Planning Commission Issues Report

Subject: Change of Zoning Issues Report

Petition: **P.Z. 16-2013 Wilmas Farm (17508 Wild Horse Creek Road)**

Figure 8: Common Open Space

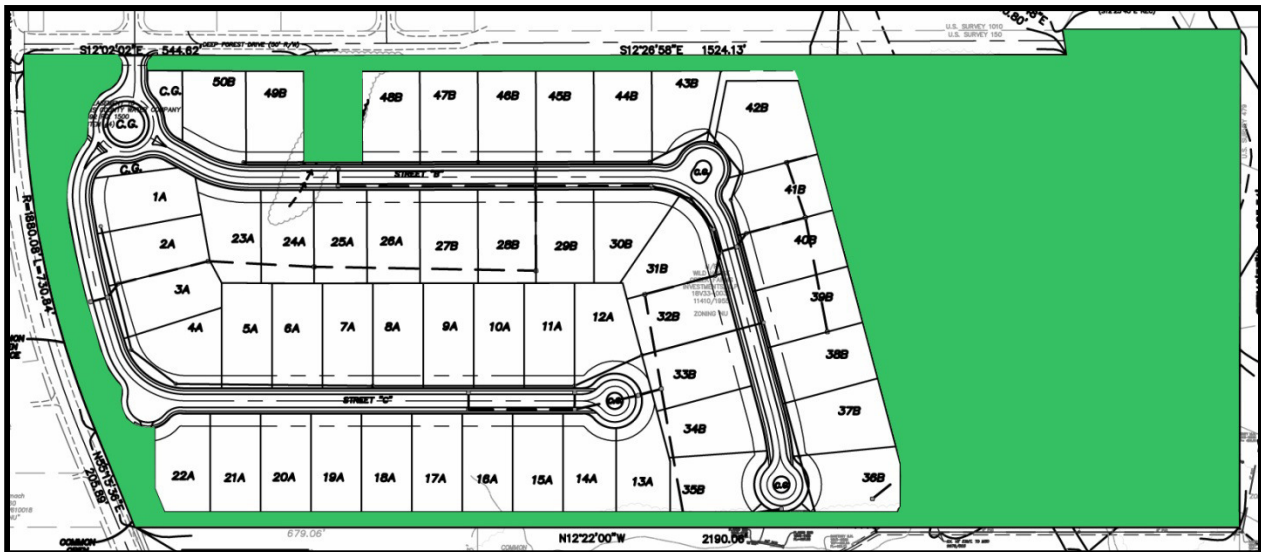
The Applicant does propose 41.4% Common Open Space, but the majority of it is still concentrated on the southern portion of the site which has restrictions associated to it as it lies in the floodway and floodplain. The Applicant, however, did increase the Common Open Space by dedicating the required landscape buffer as Common Open Space throughout the perimeter of the development. The image below illustrates the location of the Common Open Space, in green, on the site.

Staff recommends Planning Commission consider the displacement of the Common Open Space open on the site, as majority of the Common Open Space is still concentrated on the southern portion of the site.

Wilmas Farm
 Chesterfield, Missouri
 NATURAL RESOURCE MAP

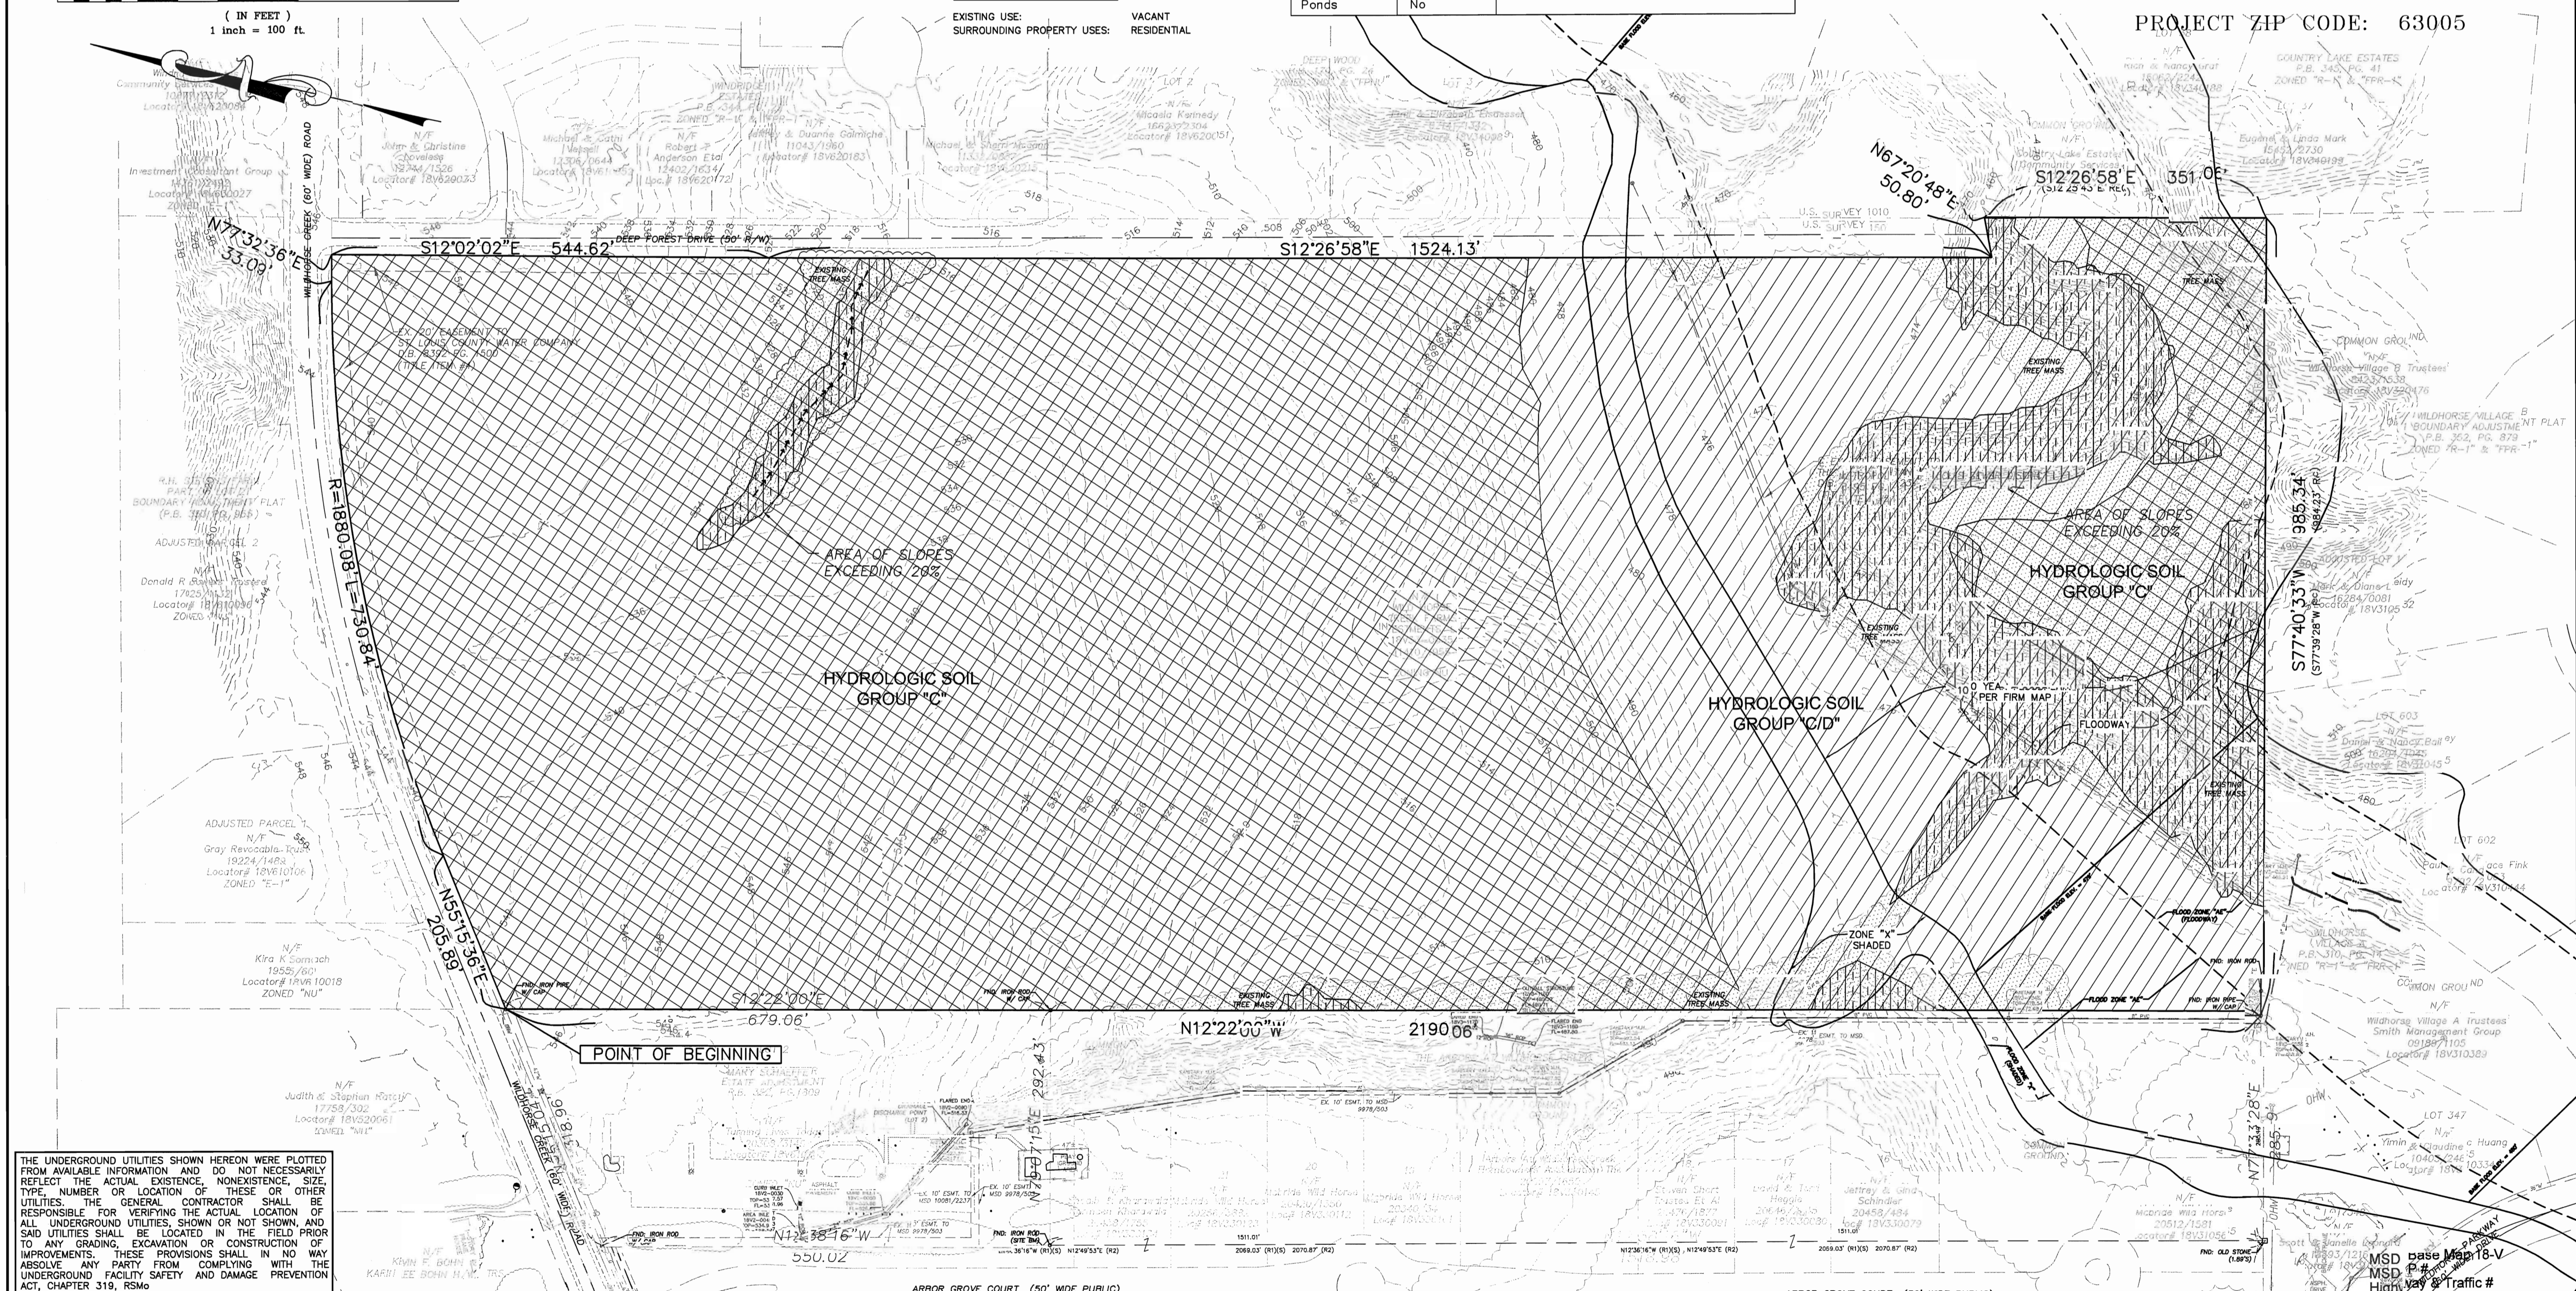
The original and amended Preliminary Plan show one (1) public access point off Deep Forest Drive and an emergency access point off Wild Horse Creek Road. Staff recommends and standard practices are to provide more than one point of access. In addition, the Comprehensive Plan recommends more than one point of access for emergency vehicles. This is imperative in order to provide public services as well as to allow more than one point of ingress/egress for residents especially in the case of an emergency.

Although, the Applicant notes they have met this requirement by providing a secondary emergency access only, Staff highly recommends a second public access point. This is to ensure residents have adequate routes for ingress/egress to the development, especially during emergency situations. Additionally, this is generally considered to be a good planning practice.

A minimum twenty (20) foot wide storm water control easement(s) is required per the City of Chesterfield Municipal Code, to provide access for the maintenance and upkeep of the proposed storm water basin. The Applicant is proposing the easement through the required thirty (30) foot buffer along the western perimeter, near Lot 36. Staff has concerns about this and is not satisfied with the proposal as presented, as the landscaping will have to be removed to provide access for heavy equipment needed for the maintenance and upkeep of the proposed storm water basin. The Applicant has noted provisions of easements and/or indentures to assure replacement of landscaping if removed; however, Staff believes this will be difficult to enforce and highly recommends the easement be provided outside of the required perimeter buffer.

The length of the proposed cul-de-sac(s) shown on the Preliminary Plan exceeds the maximum length for a cul-de-sac as set forth in the Street Matrix within Section 1005.180 of the City of Chesterfield Municipal Code. This could affect the layout of the proposed lots in the Preliminary Plan. The Applicant has noted they will be submitting a modification request for this requirement; however, Staff has not received this request. All such requests are reviewed and approved by the Planning and Development Services Director; however, in the case of a "PUD" the Director's recommendation will be forwarded to the Planning Commission. As this request has not yet been submitted, a formal recommendation and decision cannot yet be made on it. This will be addressed prior to the final preliminary plan being forwarded to the Planning Commission for a Vote Meeting. While this determination is handled by Staff, Staff will keep the Planning Commission apprised of the status of said request.

4. Two (2) public access points are required for this development. The emergency access shown on the plan does not satisfy the requirement of the second public access. Amend the Preliminary Plan to show the two (2) public access points to the development.

6. The length of the proposed cul-de-sac(s) shown on the Preliminary Plan exceeds the maximum length for a cul-de-sac as set forth in the Street Matrix within Section 1005.180 of the City of Chesterfield Municipal Code. Amend the Preliminary Plan to ensure compliance with this requirement.

Petitioner believes it has satisfied both the Comprehensive Plan and the applicable City Code provision by providing a secondary emergency access that the Fire District has approved (copy of letter enclosed). Both the Comprehensive Plan and the City Code provisions state as follows:

These provisions clearly state that the purpose of a second entrance is to serve emergency vehicles. Petitioner has provided a secondary emergency access that has been approved by the Fire District. A full access at Wild Horse Creek Road is also problematic because of the topography of the site (it falls off from Wild Horse Creek Road) and there is a limit to the amount of fill that can be placed over the water main. Utilizing Deep Forest Drive to provide full access to the development avoids another curb cut on Wild Horse Creek.

The maximum length is exceeded by only approximately two hundred (200) feet (the width of two lots). It is problematic for Petitioner to move the cul de sac. Consequently, Petitioner will separately request a variance and provide justification for the request in accordance with the City's applicable procedure.
